MYO MONITORING REPORT

PHANTOM MILL

Response to IRT Comments – MY 0, Baseline Report

Response to DMS Comments

Figure 1. Current Conditions Plan View

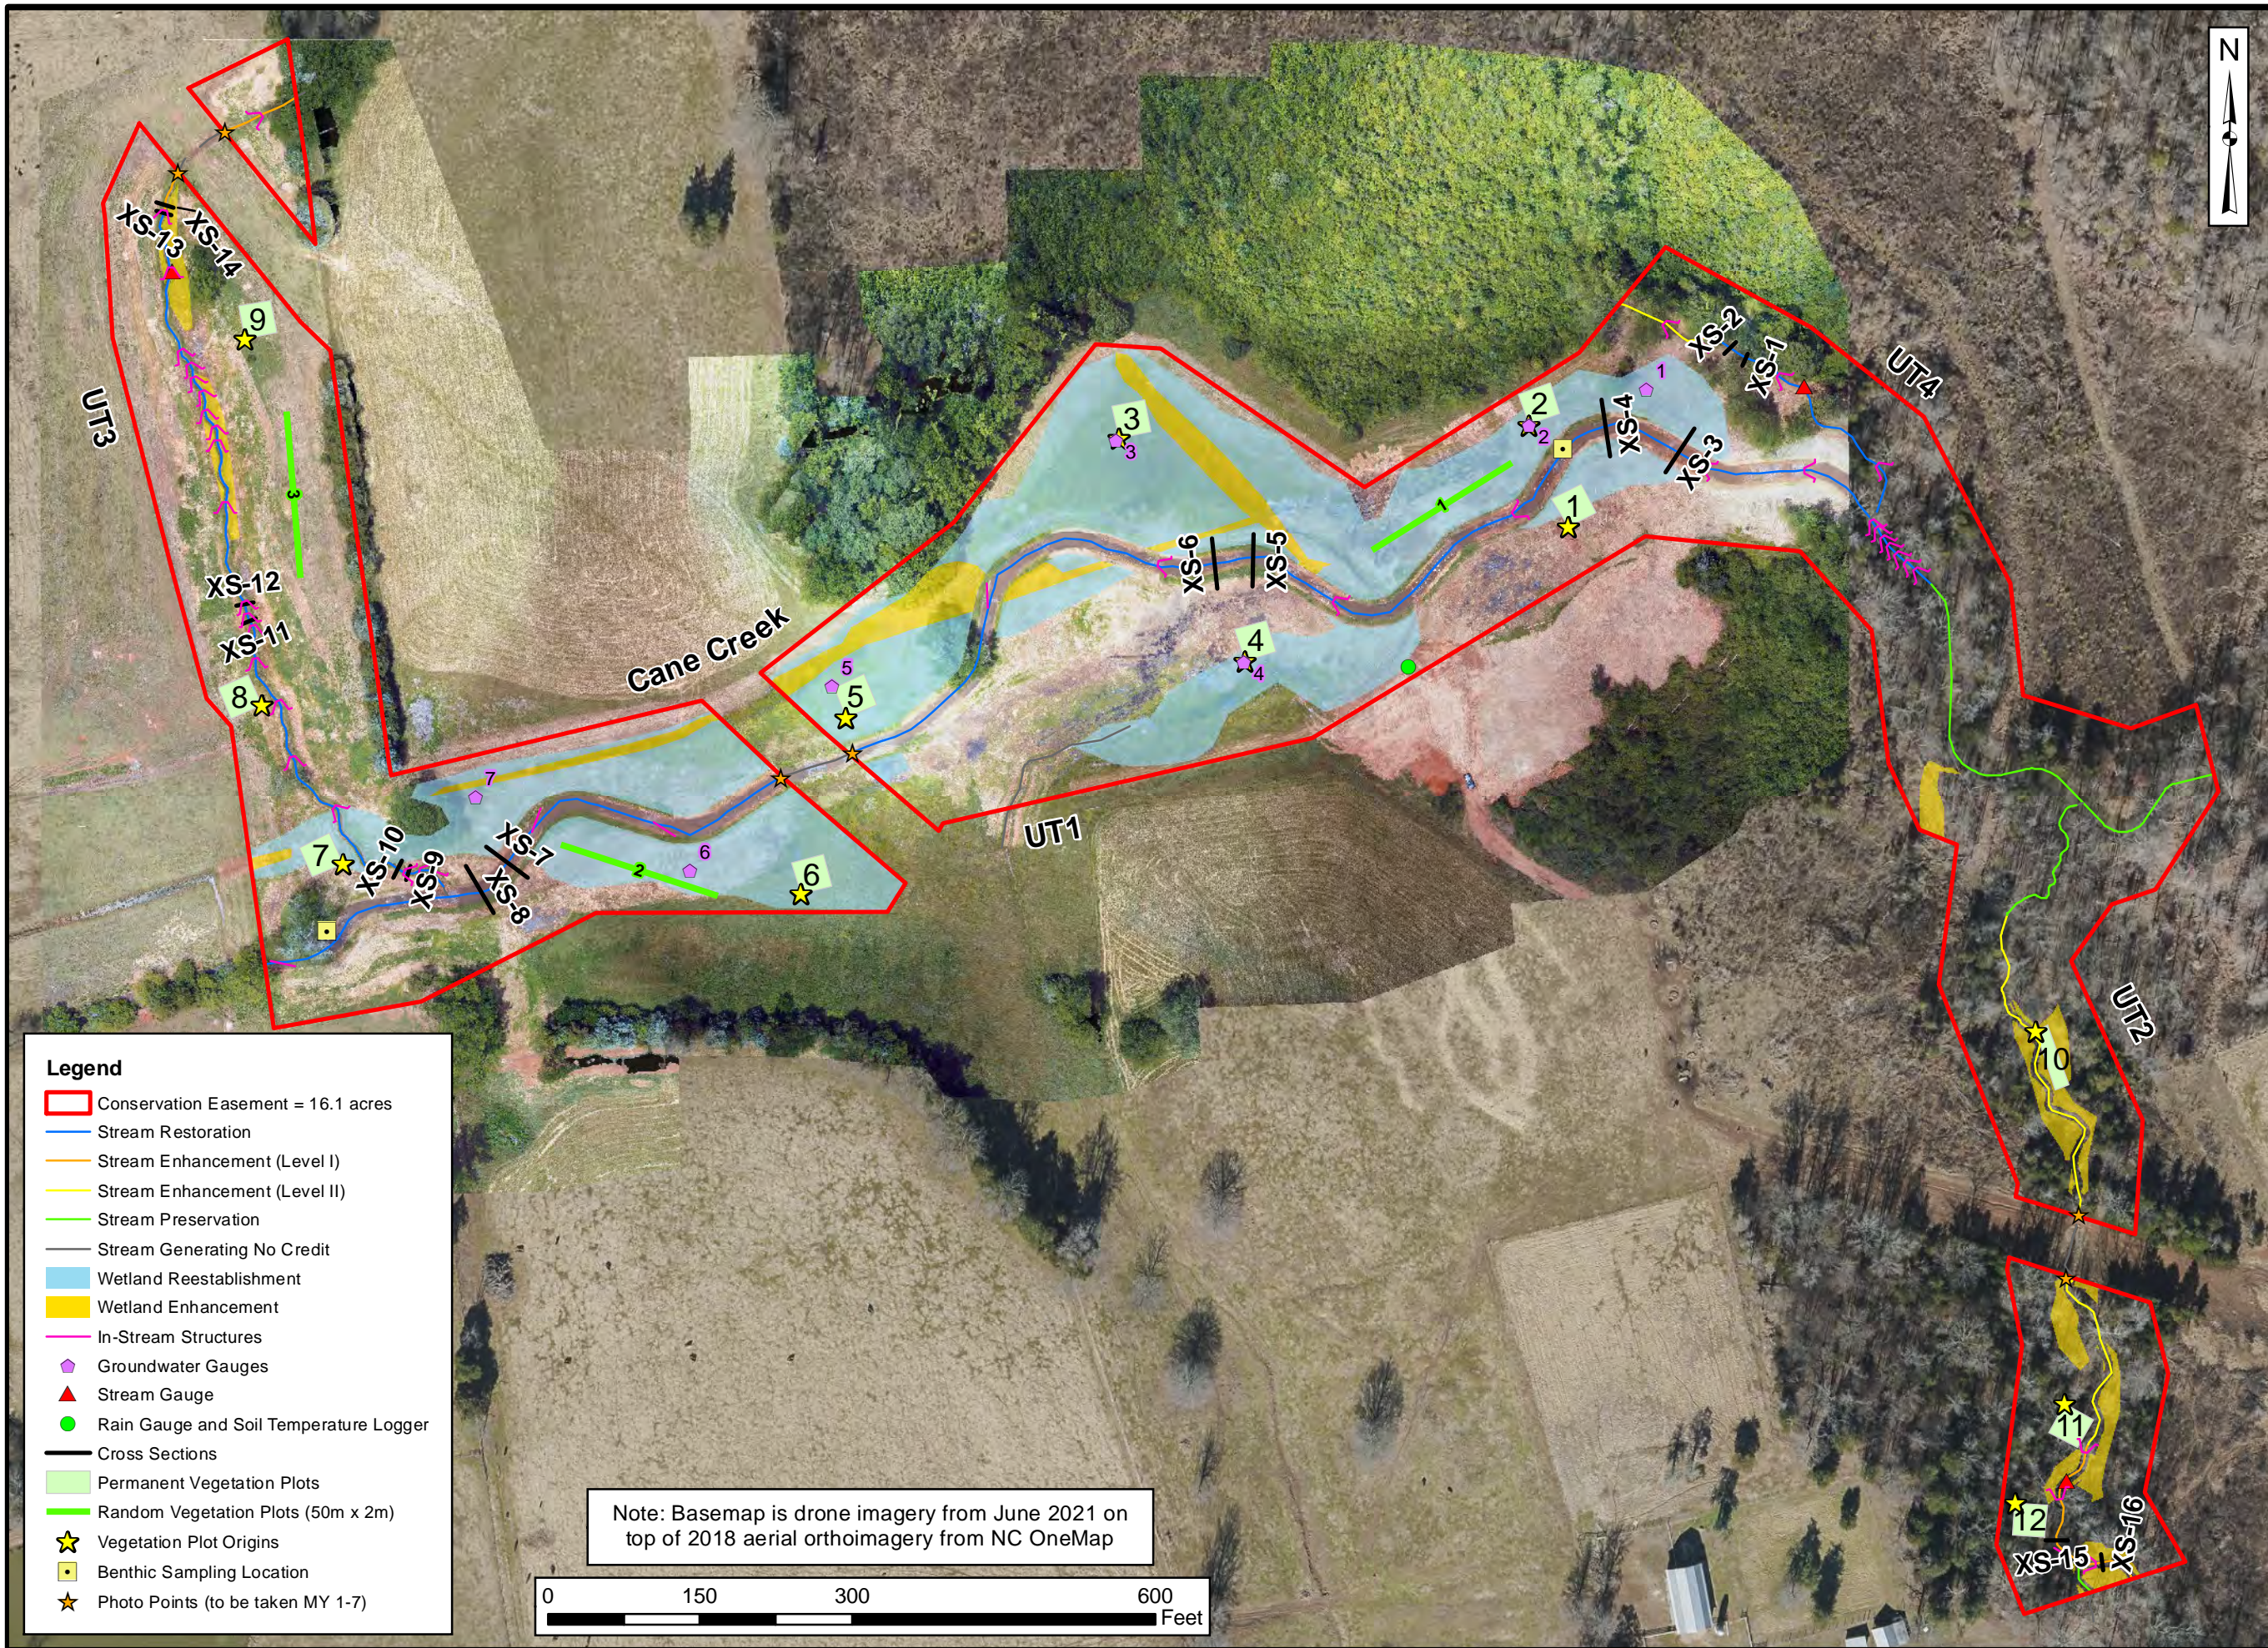
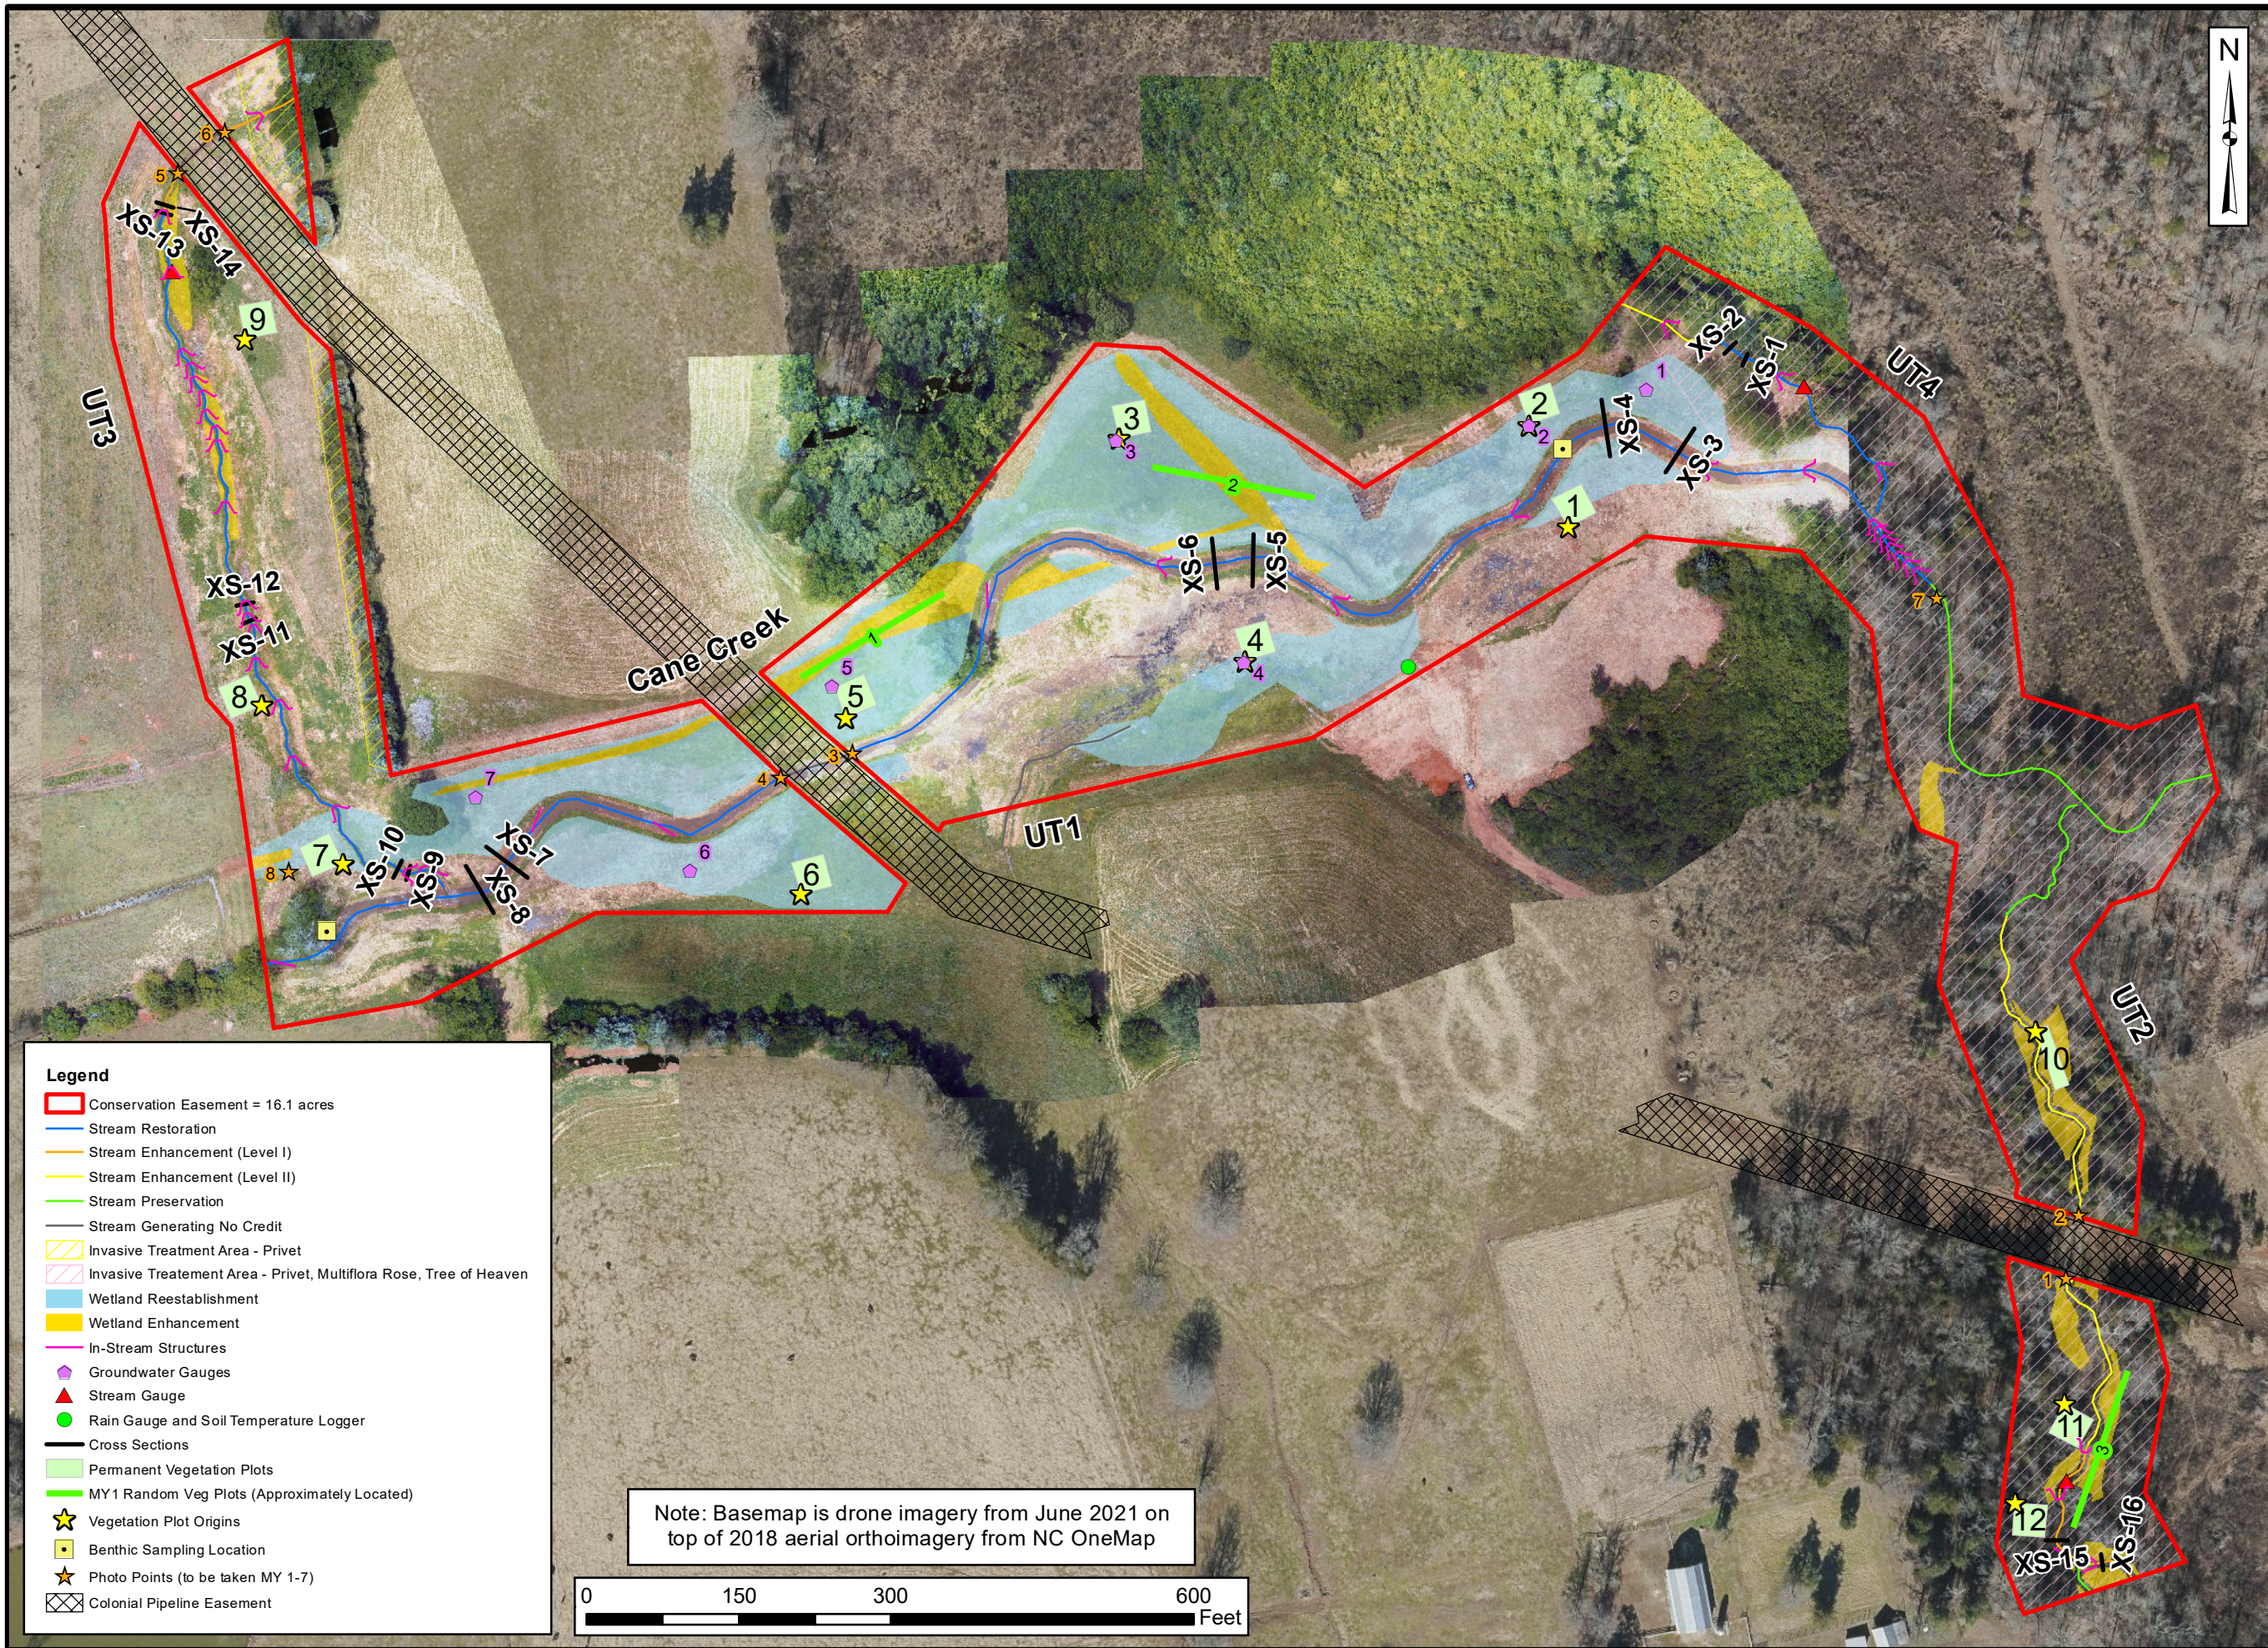
4. It would be helpful to show the location of the pipeline, and any other utilities on Figure 1.
Response: The pipeline easement will be added to Figure 1. No other utilities exist onsite.

5. Table 5: What is the total acreage of invasives on site? Was this not listed on Table 5 because it was below the mapping threshold?
Response: Invasive species occurrences observed onsite were sporadic and below the mapping threshold; however, spot treatment of privet and multiflora rose has occurred since as-built measurements. Treatment areas will be depicted on Figure 1 in the MY1 report.
